| NOTE | REVISION NOTE | | | | REVISION NOTE | | |
|---|---------------|--|-----|------------|---------------|-------------|---|
| 4. Critical dimensions to be taken from site. | E | ISSUE FOR SECTION 4.55 NO.2 APPLICATION | | 20/6/2023 | | | |

| | RELOCATED. | |
|-------------------------|-----------------------|---|
| AIRLIGHT BOARDING HOUSE | MO, LN & KL | MO |
| EVEL 1 PLAN | 1:100 @ A1 | 20025 |

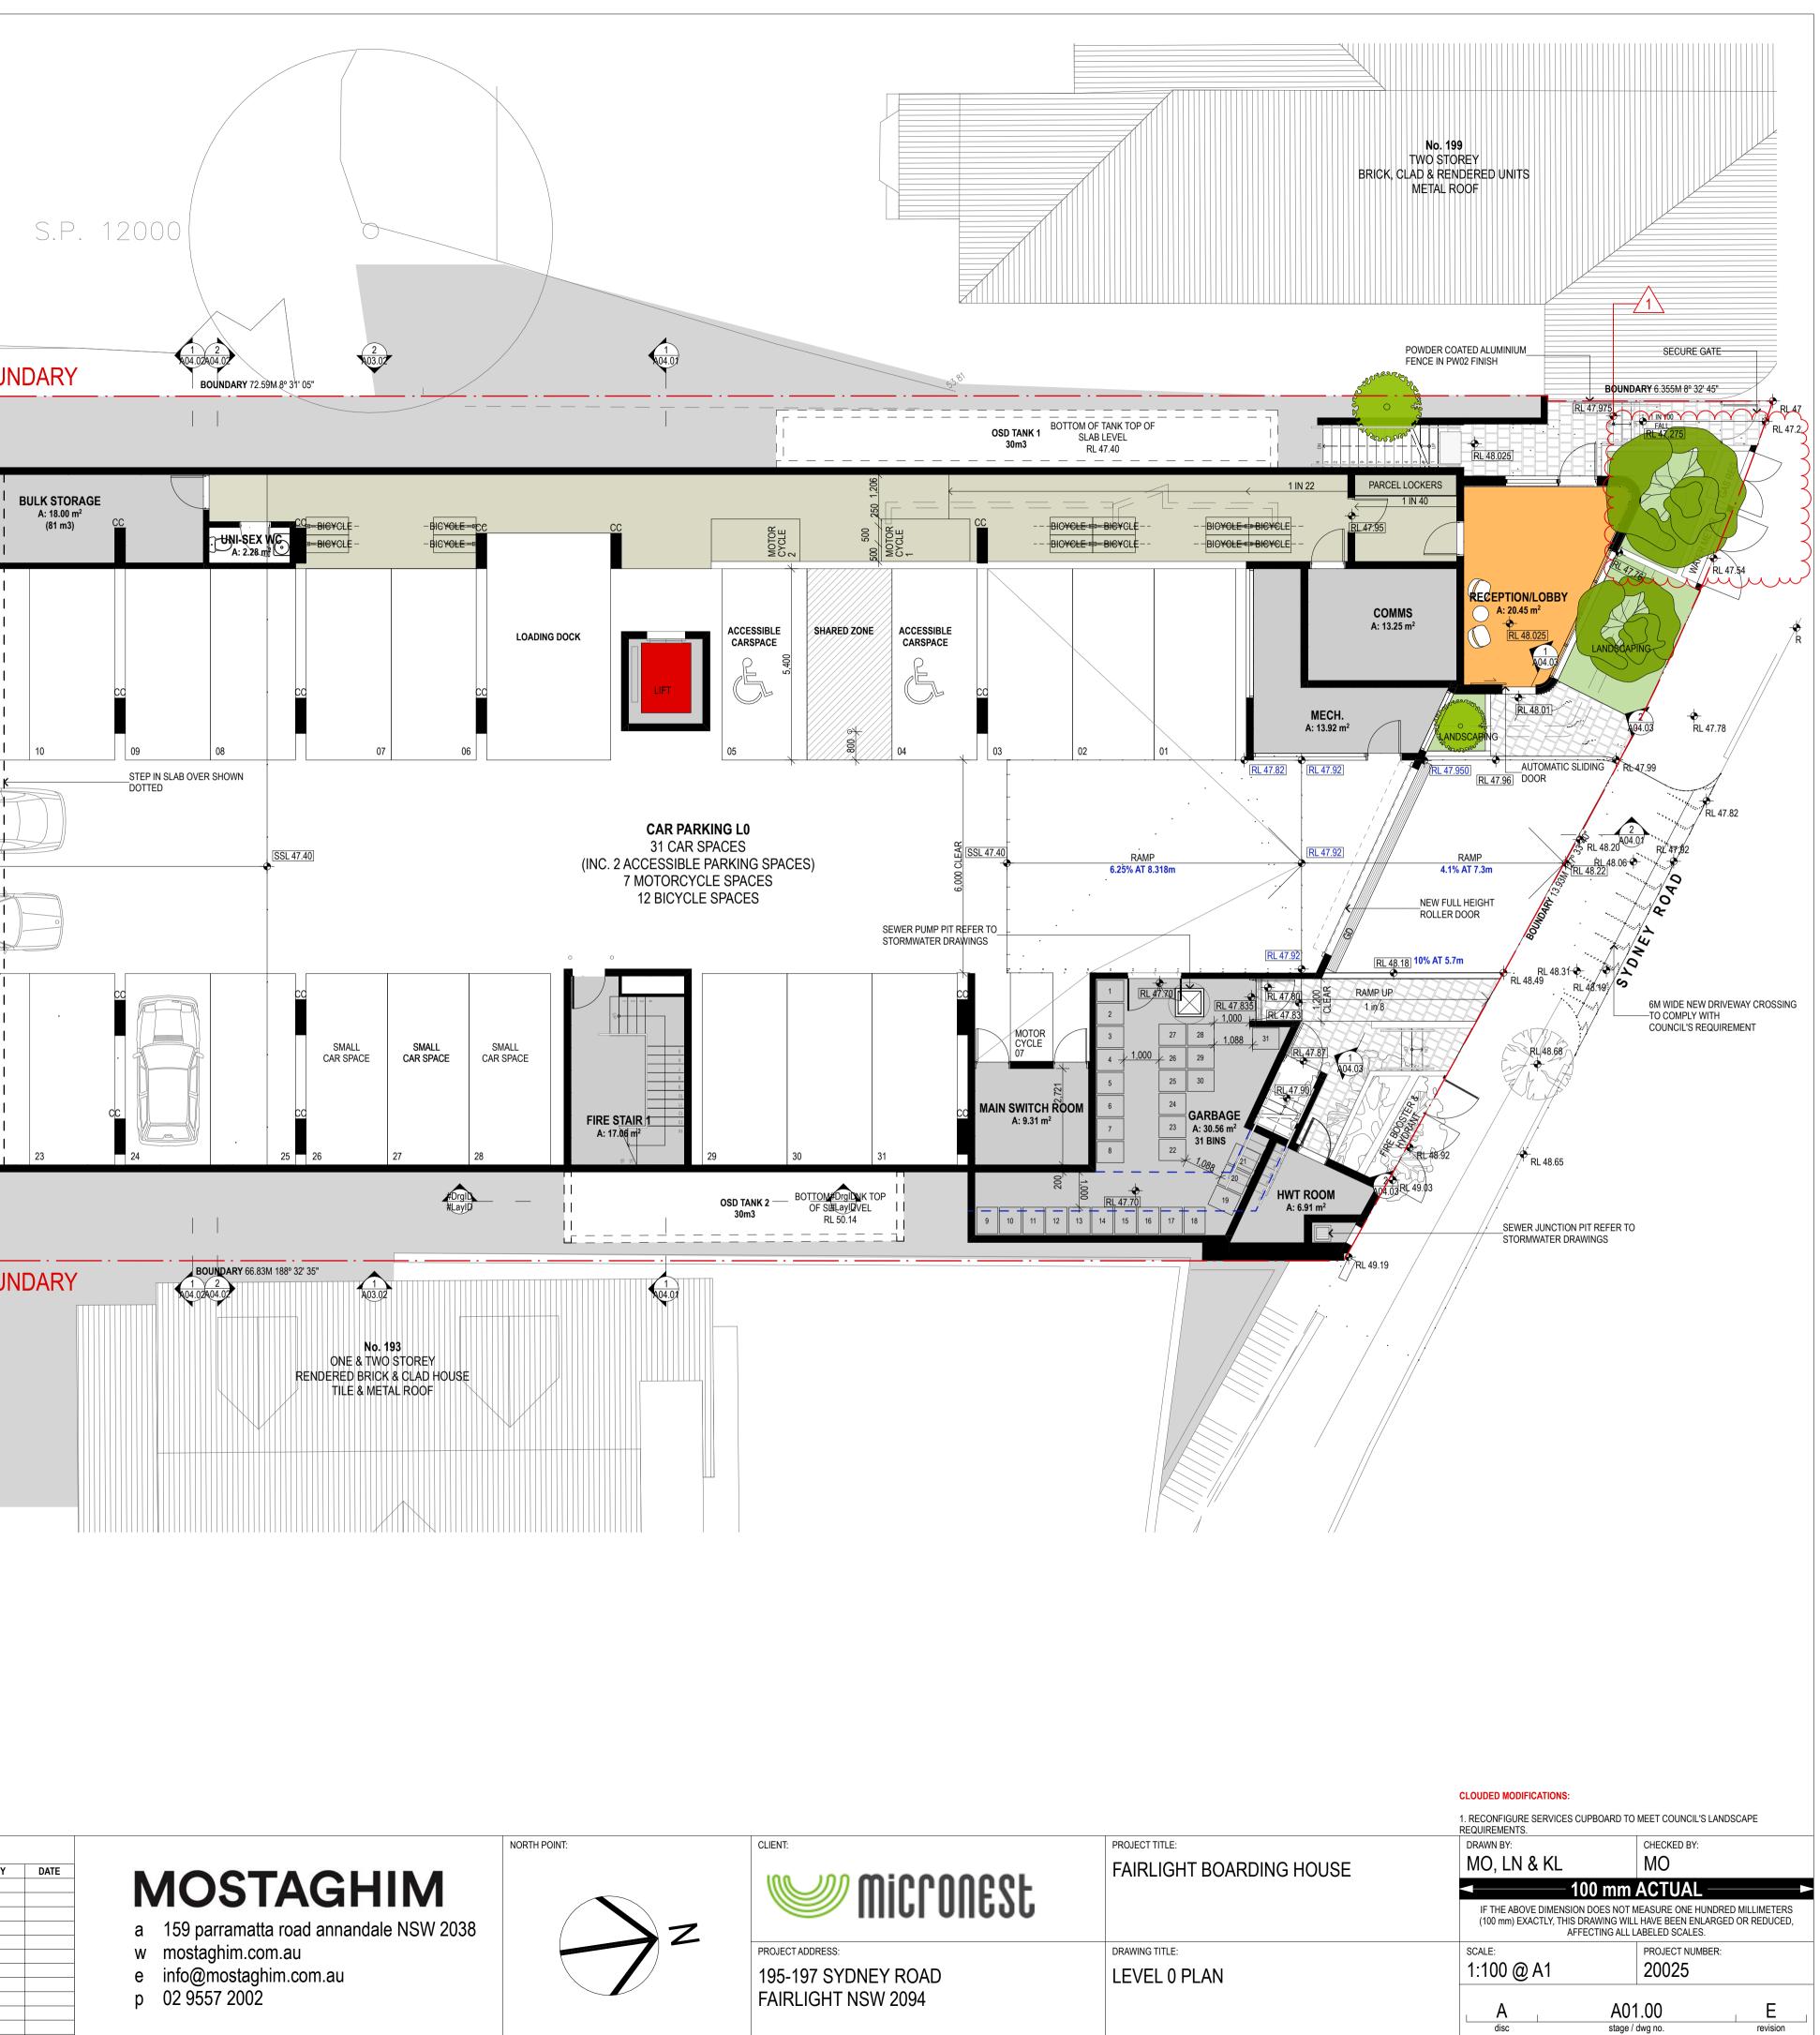
| | RELOCATED. | |

| | CLOUDED MODIFICATIONS: | | | |
|--------------------------|---|--|--|--|
| LEVEL 2 PLAN | 1:100 @ A1 | 20025 | | |

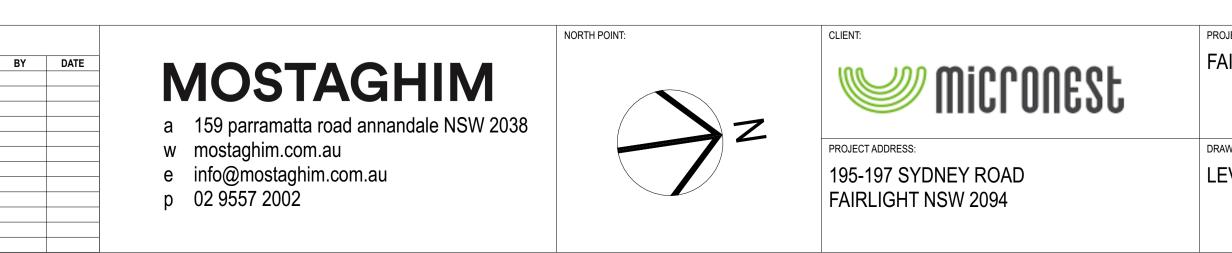
| | CLOUDED MODIFICATIONS: | | | |
| | 1. RELOCATE LAUNDRY FROM LEVEL 2 TO LI LAUNDRY ON LEVEL 2. | EVEL 1 AND PLANT ROOM IN LIEU OF | | |
